PROPOSED CHANGES

The request is to approve a REVISED previously approved (and now partially completed) preliminary development plan for a residential planned unit development with changes to the building styles and layout of the northwest corner. The changes are to the northerly portion and other future phases of the PUD are to remain as previously approved. The previous revised preliminary approval in 2021 was submitted to rework the road layout and provide route for sanitary sewer. That revision resulted in a reduction of 5 units from the previous approval, going from 834 to 829. This currently proposed revision is requested to change the style of buildings in the northwest corner of the PUD and reduces the overall number of units from 829 to 782. It includes:

SUMMARY and MOTION for (PUD2502) the Preliminary Development Plan

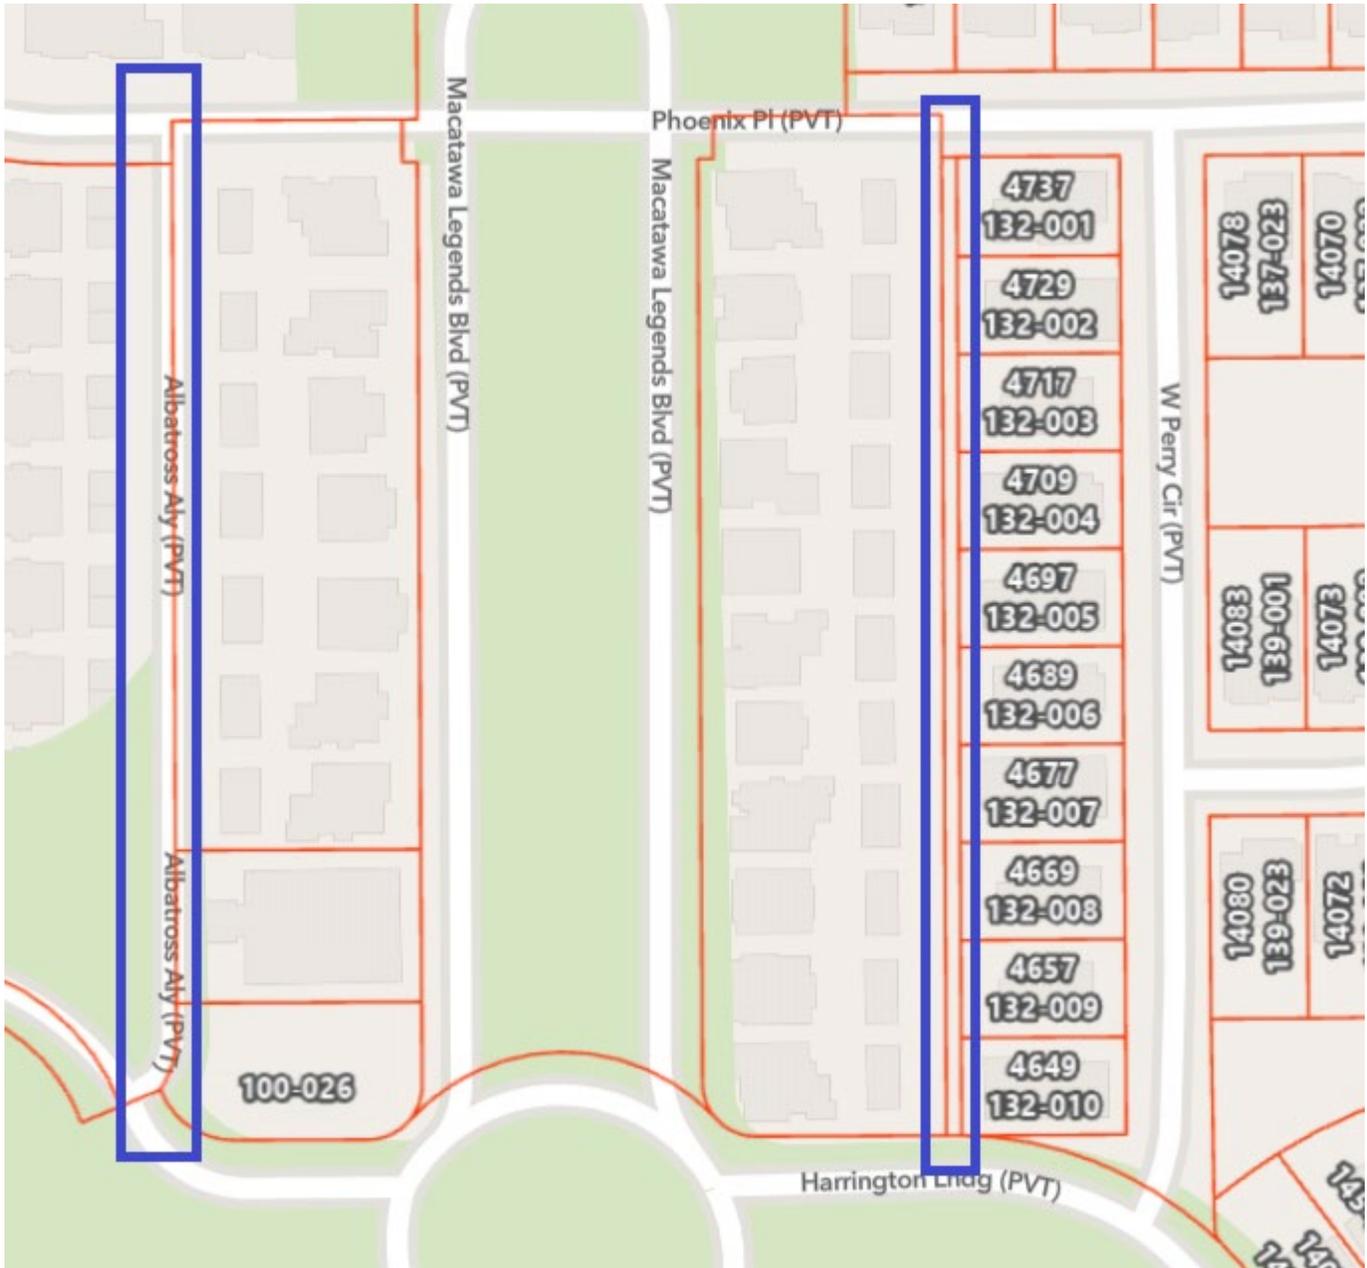
C. **Example.** Macatawa Legends, in Holland Township, is an example of the proposed new building types called Terrace units and Townhomes, **with detached garages having alleys that provide access to the garages.** Note that each of these Macatawa Legends units **has primary access from a private street and secondary access to the garages from an alley.**

D. Determination. Based on the Zoning Ordinance language, specifically stating that an **alley** provides a secondary access and a street provides the primary access, the determination is as follows:

1. The drive aisles labeled as PRIVATE ALLEY are really private streets which provide the **ONLY** access to the middle four rows of units (not secondary access).

2. Further, the Township general ordinance related to sidewalks requires the installation of sidewalks adjacent to all paved streets. Since the determination is that these are private streets, sidewalks shall be installed adjacent to the drive aisles now labeled PRIVATE ALLEY and PRIVATE ROADS A, B, and C. Note that there is an opportunity to request a sidewalk waiver from this requirement from the Township Board. Due to the fact that sidewalks are shown along the REAR yard, this could be provided as information to the Township Board.

3. Requested modifications should include the following:
 - a. front yard setbacks (from the private street),
 - b. rear yard setbacks from the sidewalk in the park area,

- c. side yard setbacks between each Terrace unit,
 - d. to have detached garages, and
 - e. to locate the garages in the front yard.
 - f. to locate a six foot fence in the front yard.

*Proposed Setbacks

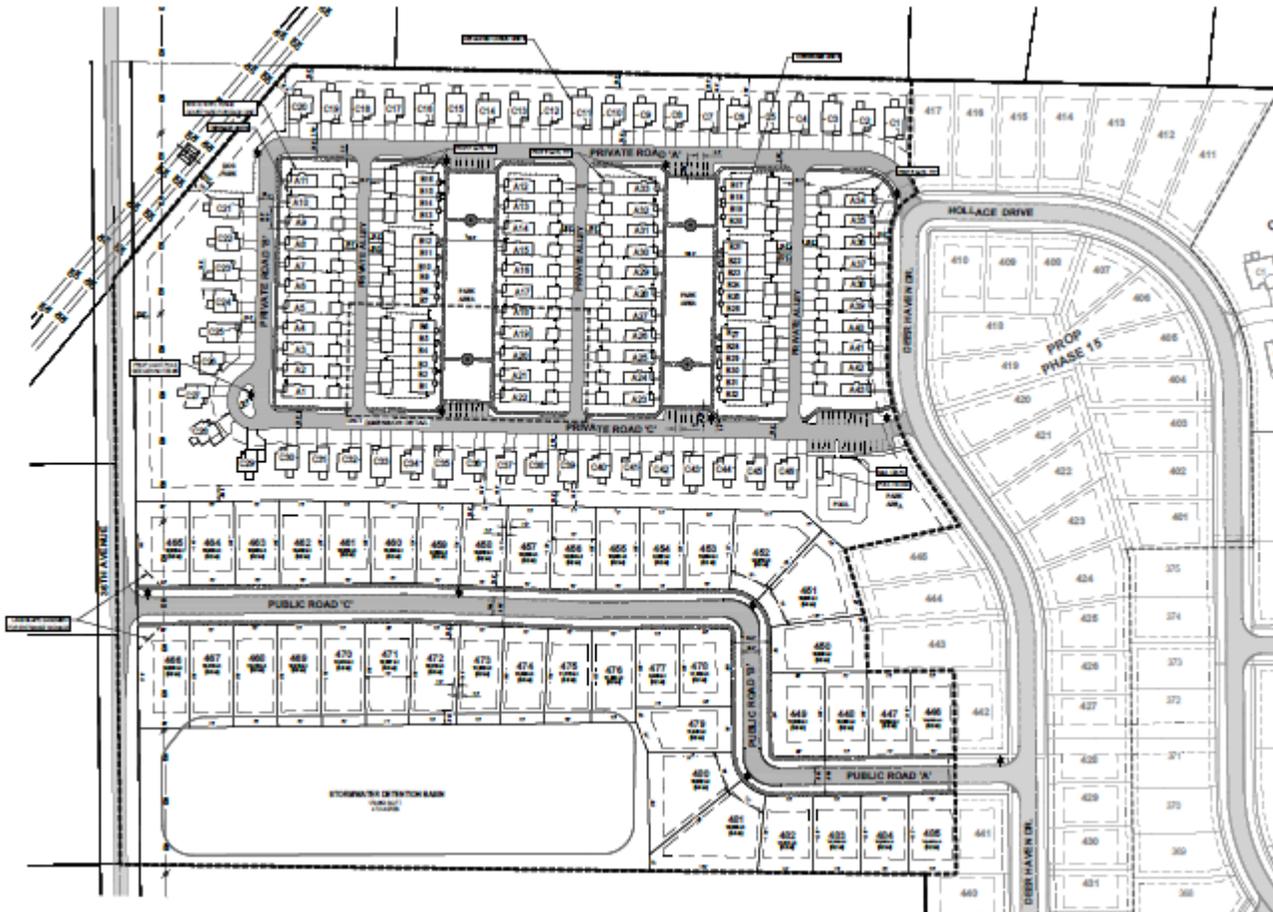
- a. **For all Terrace and Townhome Units with detached garages, the garages and the fences for the courtyards are located in what the Zoning Administrator has determined to be the front yard. Note that the applicant’s plan has switched front and rear yard due to the orientation of the homes. For zoning purposes, the front yard is the side adjacent to the street.** Note that this is incorrectly represented on the plan as per Zoning Ordinance definitions. The applicant incorrectly states that the front yard is the yard adjacent to the park area (which is actually the rear yard as per Ordinance definition) and incorrectly states that the rear yard is the yard adjacent to the private street (which is actually the front yard as per Ordinance definition). To alleviate any future confusion, a condition of approval could be added to the motion to required a revised site plan with the correct designations.

- g. **The Terrance Units and Townhouse Units building height cannot exceed 30’ to the eaves from the mean grade.**
- h. **A revised plan is submitted listing the front yard and rear setbacks as per the Zoning Ordinance definitions.**
